PUBLIC INTEREST REVIEW FOR GROUNDWATER APPLICATIONS

TO: Water Rights Section Date September 27, 2016
 FROM: Groundwater Section Karl Wozniak & Dennis Orlovski
 SUBJECT: Application G- 18336 Reviewer's Name
 Supersedes review of _____ Date of Review(s)

A. GENERAL INFORMATION: Applicant's Name: Davidson County: Marion

Water-Level Trends in Nearby Wells

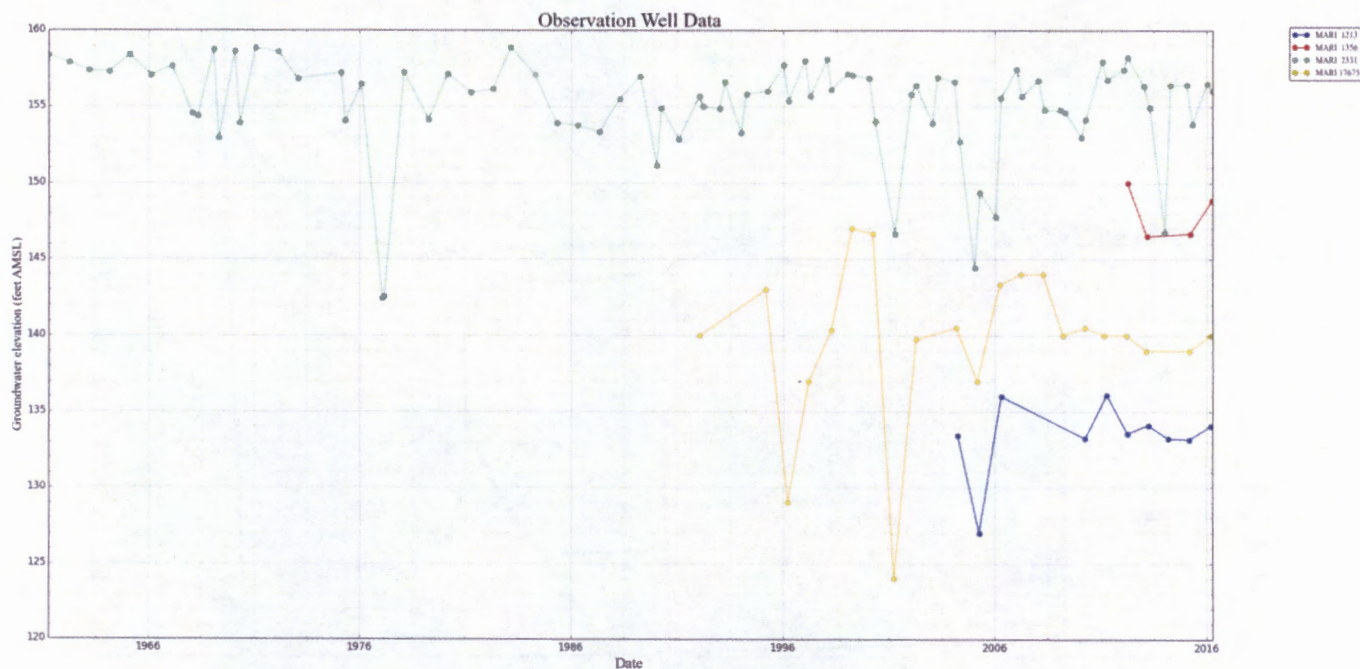
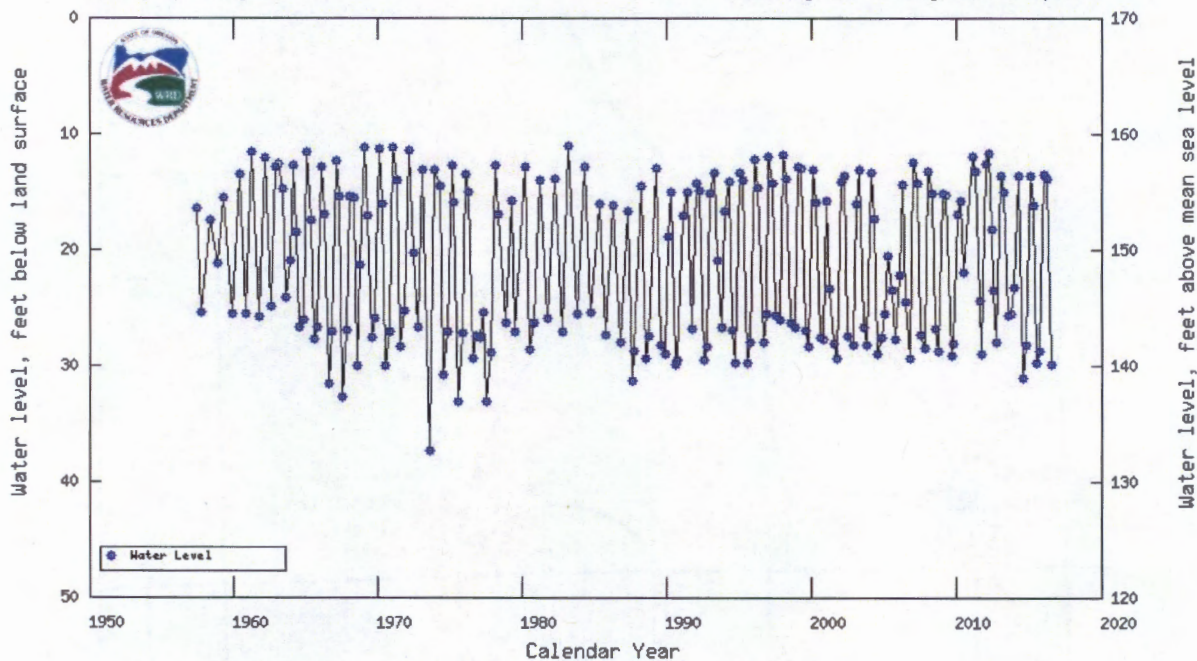
Water-level data is sparse in the immediate area but available data indicate that water levels in the fine-grained sequence under the terrace have been stable over time. MARI 2331, a state observation well located about 1.25 miles to the southeast, shows a stable long-term trend and seasonal fluctuations of about 20 feet over the last 50 years. These facts suggest that water levels are stable in the area, but the large proposed rate and the apparent lack of a thick sequence of sand and gravel beds indicate that water-use reporting and water-level measurement conditions are prudent.

G-18336 Davidson - Well 1, SW 1

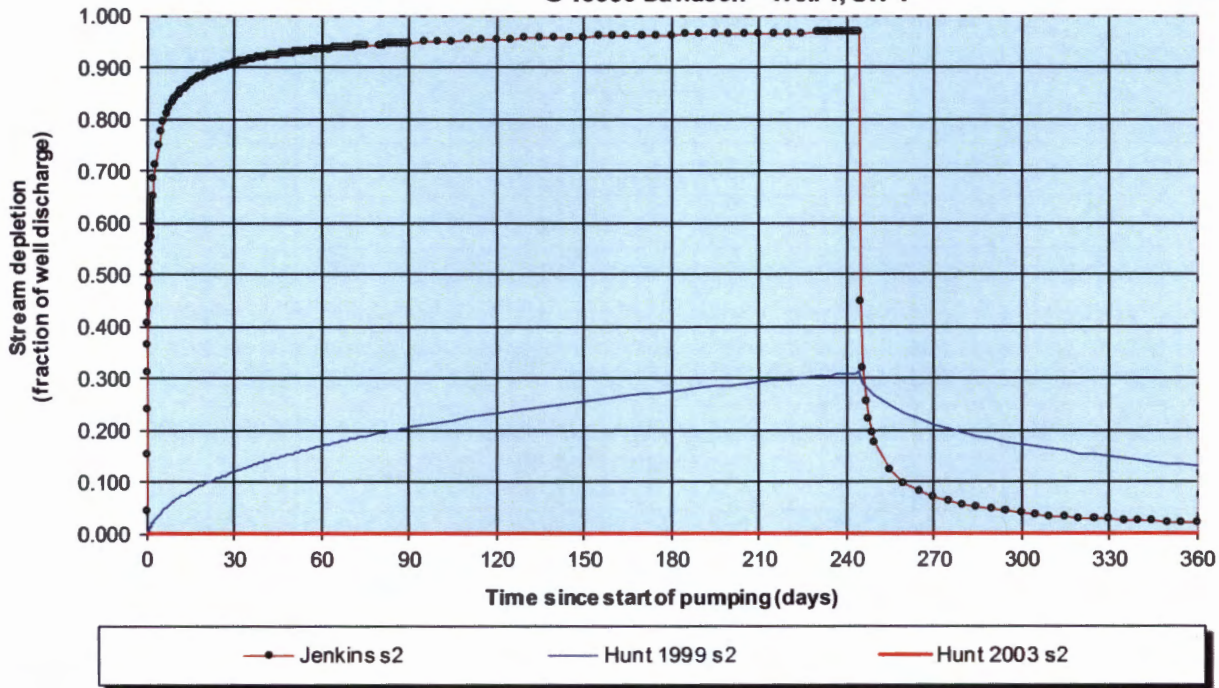
Comments: The Hunt 2003 stream depletion model (Hunt, 2003) was used to estimate depletion of Mission Creek at 30 days (Well 1, SW #1, Table C3a).

The distance from Well 1 to the nearest perennial reach of Mission Creek is approximately 4100 feet. An aquifer transmissivity (T) of 2040 ft-ft/day and storativity of 0.0001 were used for analytical modeling purposes (pumping test results from nearby wells yielded T values ranging from 706 to 2020 ft-ft/day (MARI 1448, MARI 1352, MARI 1341); the storativity value used for modeling is consistent with published values for similar confined aquifer conditions in the Willamette Basin (Conlon and others, 2005)).

The analytical model results using these key parameter values indicate that stream depletion would be considerably less than 25% after 30 days of pumping (Well 1, SW #1). A sensitivity analysis in which T was varied one order of magnitude lower and higher (204 and 20,400 ft-ft/day, respectively) yielded similar results.

G-18336 Davidson - Well 2, SW 1

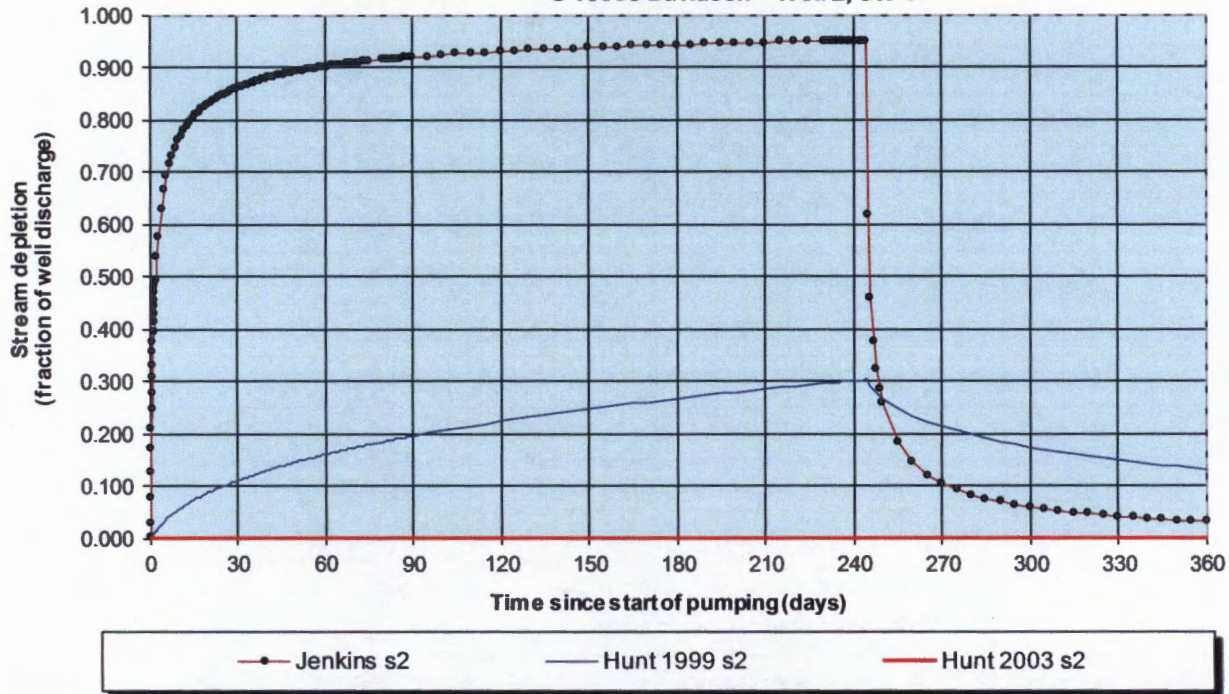
Potential depletion of Mission Creek (SW 1) by Well 2 was estimated using the Hunt 2003 stream depletion analytical model (Table C4a). For this application, a maximum permitted diversion rate of 1/80th cfs/ac (0.0125 cfs/ac) and duty of 2.5 ac-ft/ac were assumed (the requested rate of 1.65 cfs equates to the maximum permitted diversion rate (131.7 ac * 0.0125 cfs/ac = 1.65 cfs)). However, because of the inequity between the permitted rate and the duty, the duty would be exceeded after 100.8 days of continuous pumping at the maximum permitted rate. Thus a revised (prorated) pumping rate that reflects continuous pumping throughout the 244-day irrigation period (Mar 1 through Oct 31), but that allows the maximum permitted duty of 2.5 af/acre, was calculated for modeling purposes.

To derive the prorated pumping rate, the number of days to meet the duty (100.8) was divided by the number of days in the irrigation season (244). The resultant proration multiplier of 0.41 was used to reduce the maximum permitted rate such that it meets the duty if applied evenly over the entire irrigation period. For this application, a prorated pumping rate of 0.677 cfs (= 1.65 cfs * 0.41) was used for modeling purposes.

Analytical modeling results for the Well 2/SW 1 scenario, using a prorated pumping rate of 0.677 cfs, show that estimated interference is much less than 25% for the first year of use (including residual effects during the non-pumping Nov-Feb period).
